Parking Lot Specialties Expansion – Site Plan

City of Carlisle, Iowa

FOX Engineering & City Staff have completed the second review for the Parking Lot Specialties Site Plan submittal dated 11/9/21 and submitted by email on 11/10/21 and offer the following comments:

Parking Lot Specialties – SITE PLAN - 210106

LAYOUT PLAN

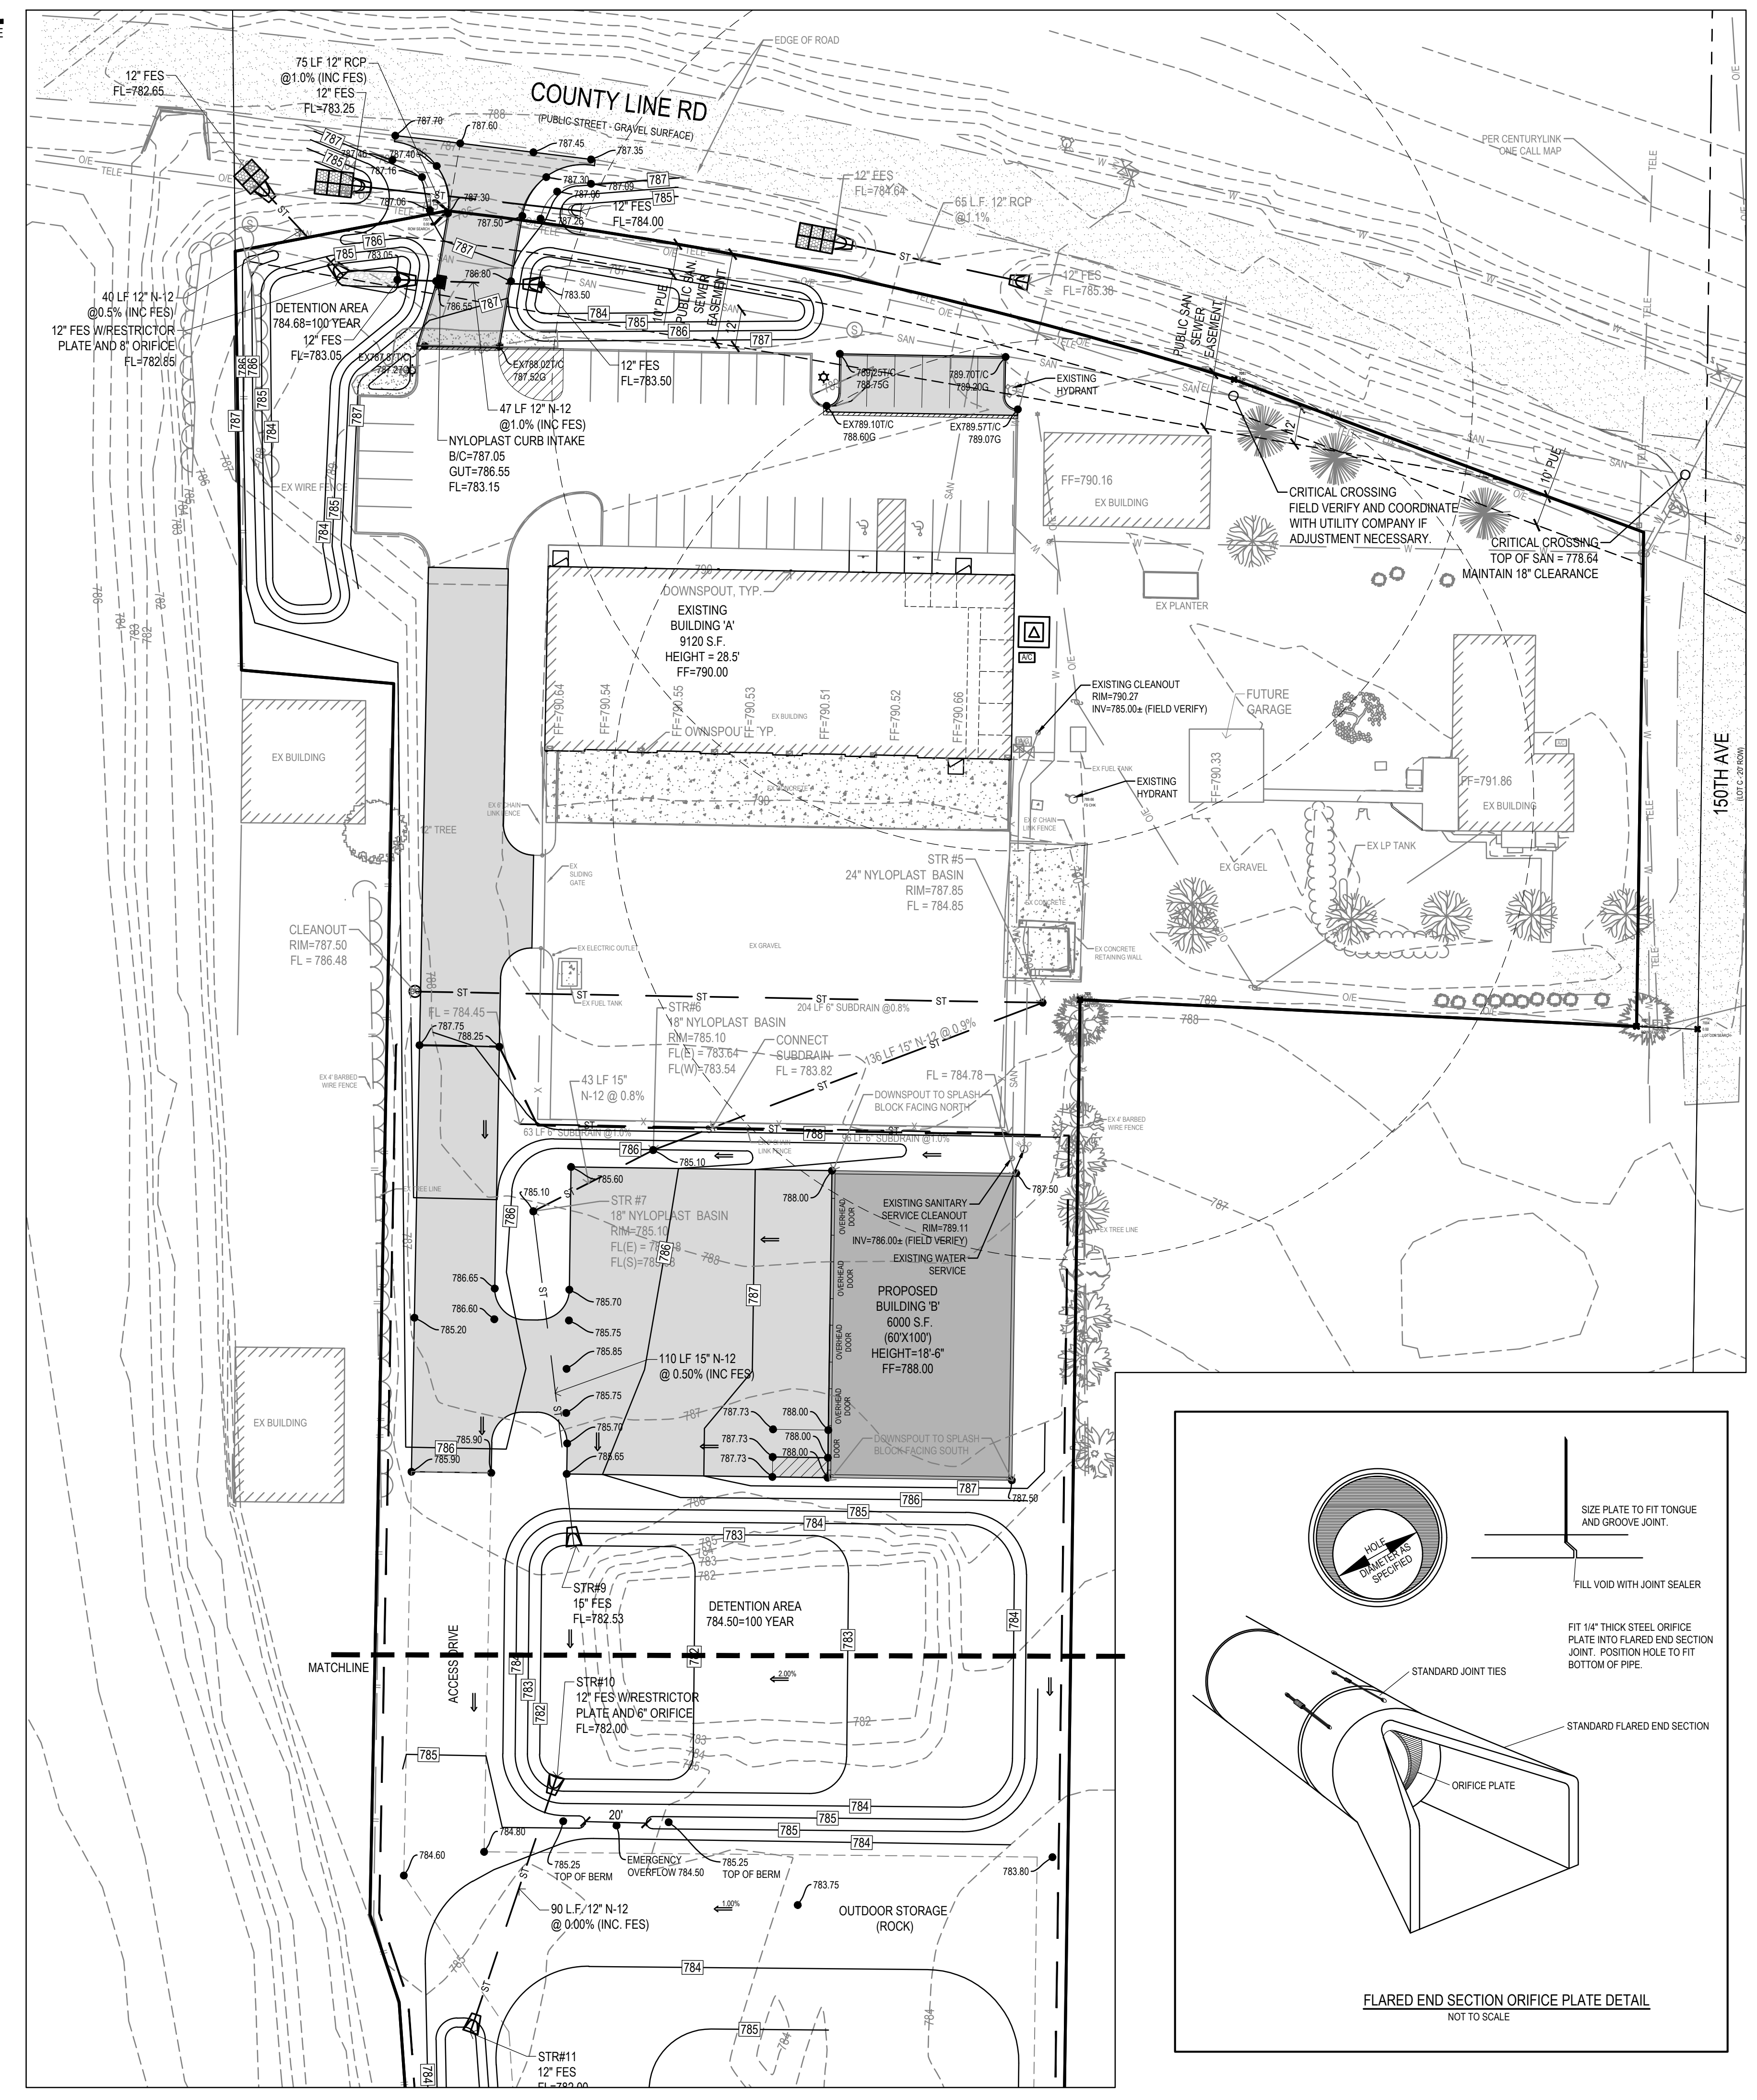
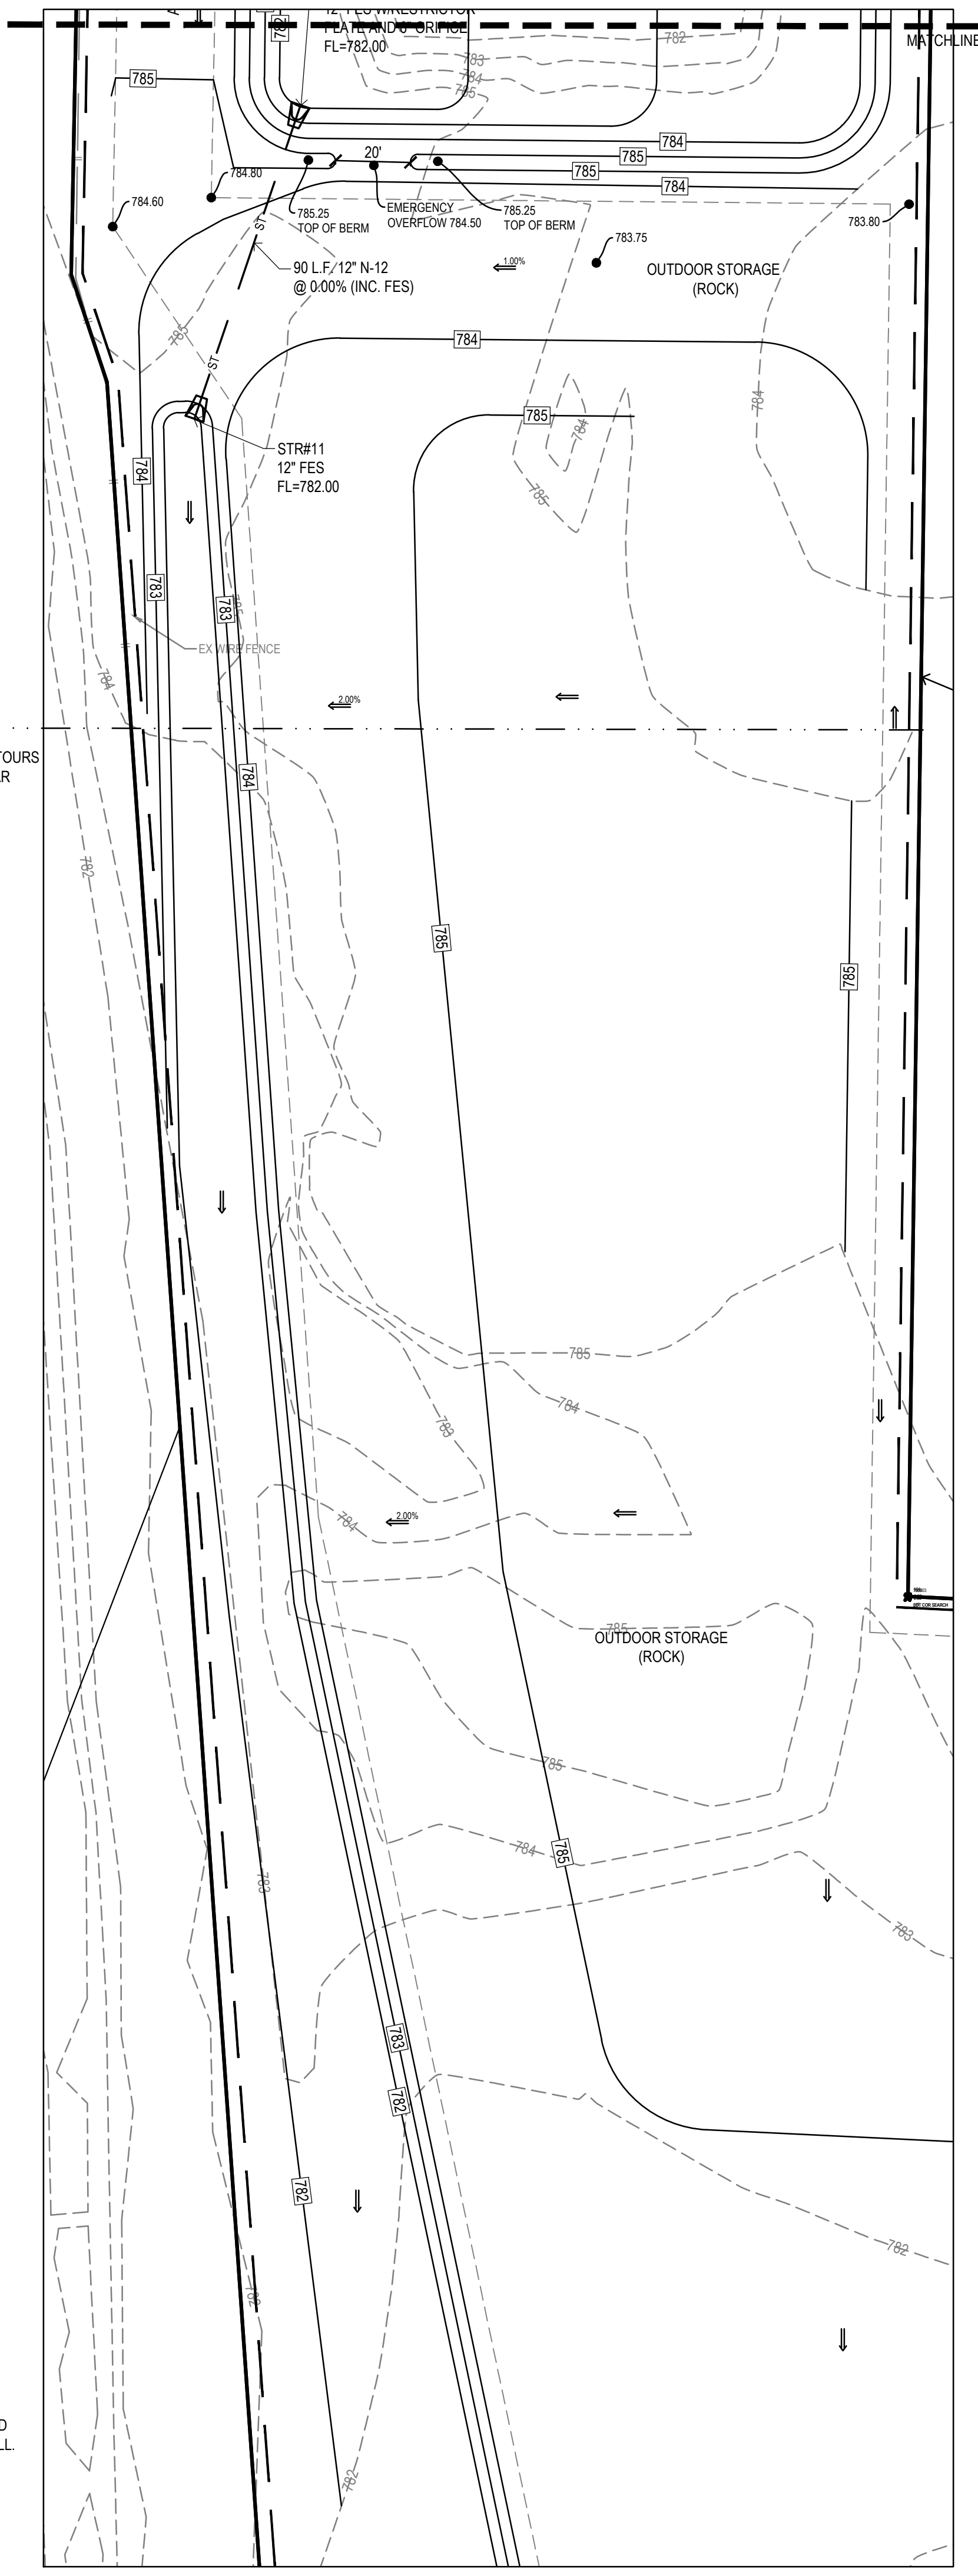
Sheet C2.1 – Layout Plan

6. Please provide screening of outdoor storage areas from adjacent property per Section 165.06, 1, E. Please be prepared to discuss this at the P&Z/Council meetings since it is not currently shown on the site plan.
7. Please clarify the type of all proposed outdoor lighting including wallpacks. Please verify it meets 165.06, 5, I of the Carlisle Code. Please verify pole height and that the fixtures are sharp cutoff.
8. Will any fencing be proposed for this site? If so, please show on the site plan and state type/size/etc. Also show any gates that will be provided on the site. Please be prepared to discuss with P&Z/Council.
9. Please show the 100-yr floodplain on this sheet.
10. Please provide a cross section for the rock area. Note that per Code, the minimum thickness for gravel parking or storage shall be 6 inches. Asphalt millings are encouraged in lieu of rock to provide dust control.

Sheet C2.1 – Layout Plan

11. The existing driveway pavement will be removed once the new driveway to the west has been constructed and open. Associated parking will be modified

12. An ADA compliant parking space has been added near the office door of the new building
13. The proposed height of the building has been added
14. The outdoor storage area is intended for immediate use with this plan approval. The label "future" has been removed

15. Proposed site lighting is via wallpacks. Additional information to be provided by the Owner
16. Locations of man doors and overhead doors have been called out

17. There is no servicing or washing of vehicles proposed in the new building/workshop area
18. The existing fence will be expanded to include the new building area and approach

19. The 100-year floodplain line has been shown on the Grading Plan. A LOMR was completed and approved in 2020 for the proposed buildings
20. There are existing trees along the west fence line and drainage way to the west. A callout has been provided. The trees can be seen in current aerial imagery

21. The paving in front of the new building is to serve as the building approach. No outdoor storage is proposed in that area. The existing HMA milling drive from the parking to the new addition is proposed to be replaced with concrete
